SINGAPORE CIVIL DEFENCE FORCE FIRE SAFETY & SHELTER DEPARTMENT HQ SCDF, 91 Ubi Ave 4 Singapore 408827 Fax: 68481493 Website: http://: www.scdf.gov.sg

13 Oct 2005

REVISION TO TECHNICAL REQUIREMENT FOR STOREY SHELTER – SETBACK DISTANCE OF STOREY SHELTER (SS) WALLS

Annex C

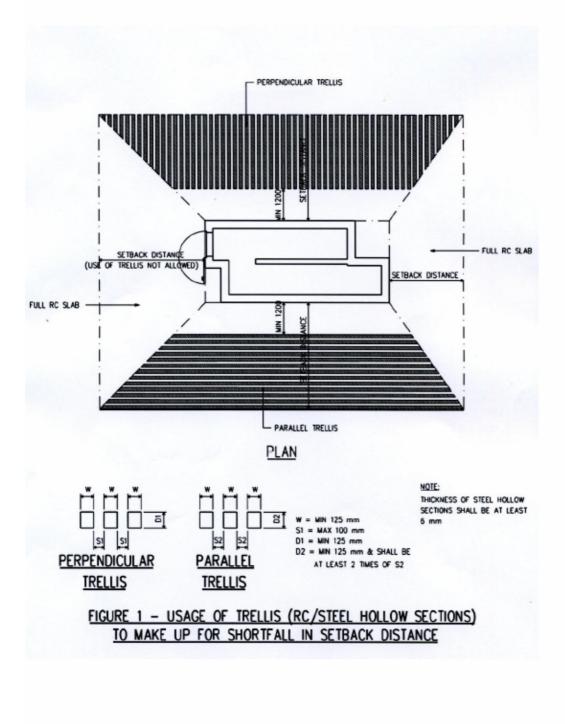
- (a) The SS walls shall be located at minimum setback distances from the EBL. The setback distances of the SS shall comply with TABLE 1.
- (b) Where the storey height of a SS on the first storey is greater than the storey heights of other SS above it, the minimum setback distances of the SS on the first storey may be the same as the setback distances of the SS above it.
- (c) For SS walls (where the SS door is not located), trellis constructed of RC or steel hollow section may be used to make up for the shortfall in setback distance. However, a minimum 1200 mm RC ceiling slab from the SS wall shall be provided (see FIGURE 1). A perpendicular or parallel trellis arrangement, or a combination of both, with respect to the SS wall concerned, shall comply with the geometrical configuration as shown in FIGURE 1.
